V2500-A1/A5 SERIES NACELLE SERVICE BULLETIN

This document transmits the Initial Issue of Service Bulletin NV2500-78-0210 and the Initial Issue of the Supplement

V2500-NAC-78-0210

NACELLE – EXHAUST – THRUST REVERSER – CASCADE ASSEMBLY – MODIFICATION OF

Cascade Assembly Fairing Removal
Figure 1

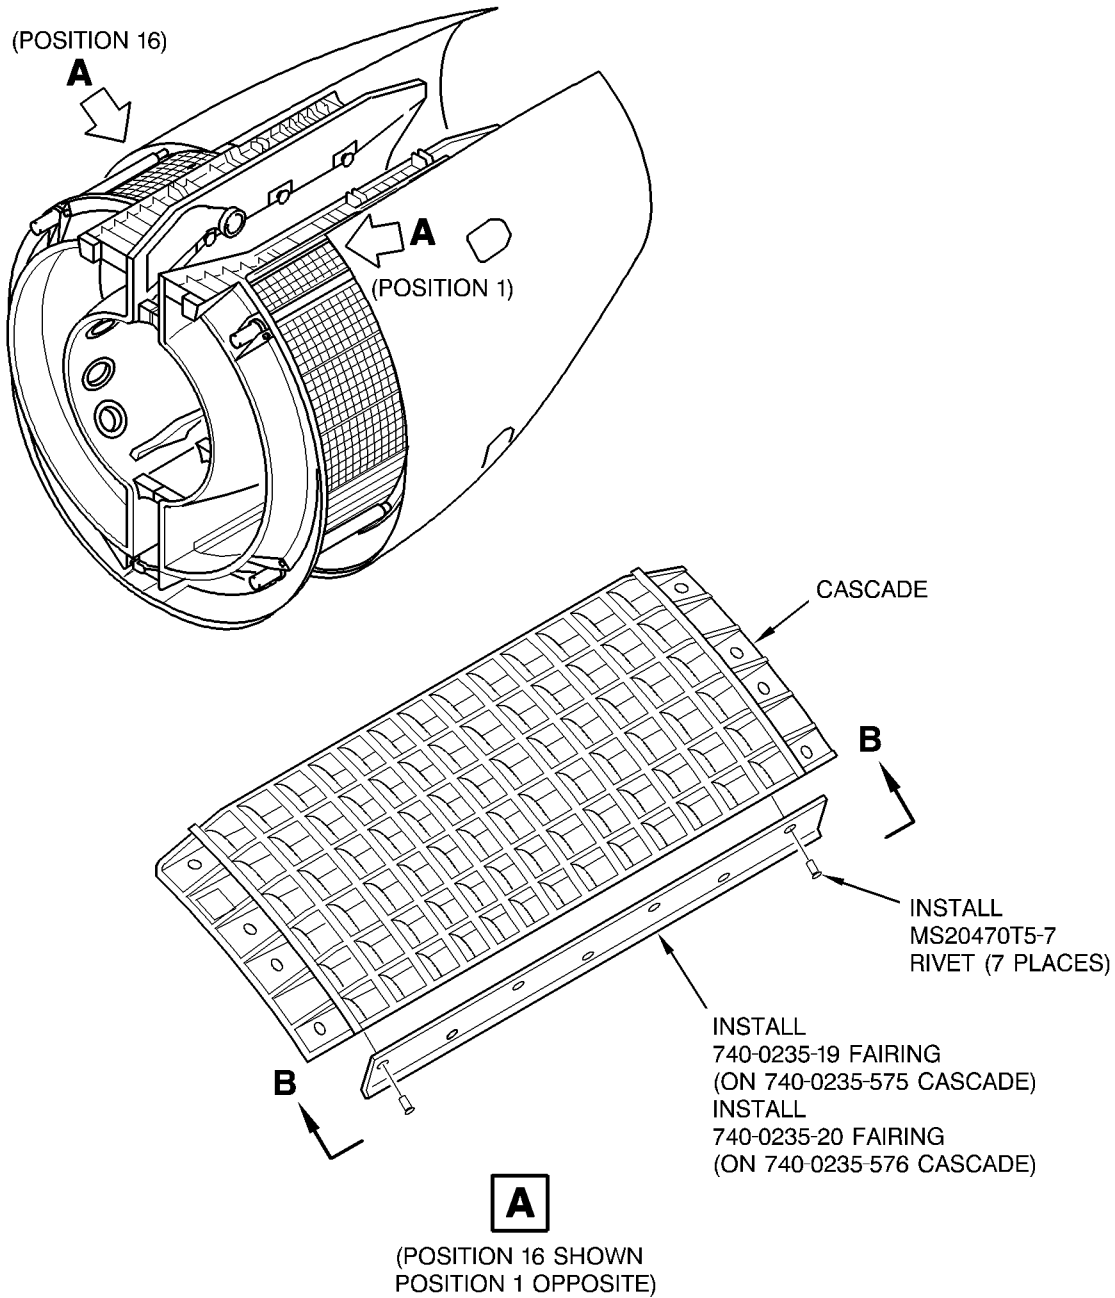
- A. Modify the 740-0235-541,-542,-577,-578 fairing for use on thrust reversers with serial numbers S/N 8367 and on.

(1) Remove the rivets and the fairing from the cascade. Keep the fairing. Discard the rivets. Refer to Figure 1.

Plug the rivet holes in the cascade using MS20470T5-6 fasteners.

(2) Re-identify the cascade assembly.

Cascade Assembly Fairing Installation
Figure 2

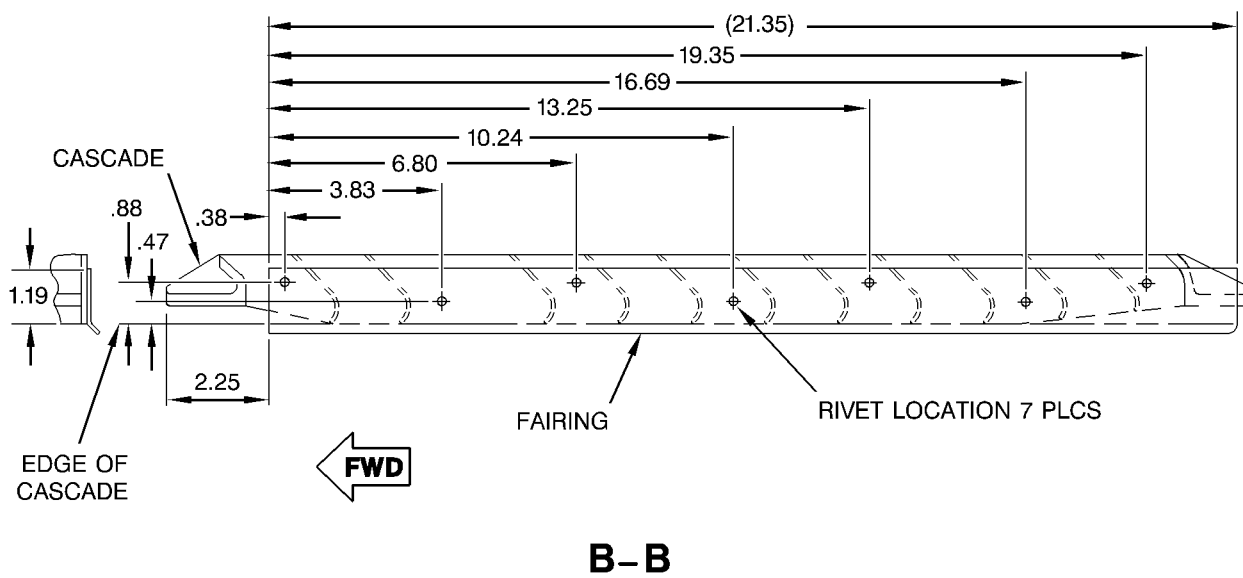
- B. Modify the 740-0235-575,-576 cascade for use on thrust reversers with serial numbers prior to S/N 8367.

(1) For new fairings, put the fairing into position on the cascade and back drill the holes. Refer to Figure 2 and 3.

(2) Install the fairing on the cascade using fasteners MS20470T5-7.

(3) Re-identify the cascade assembly.
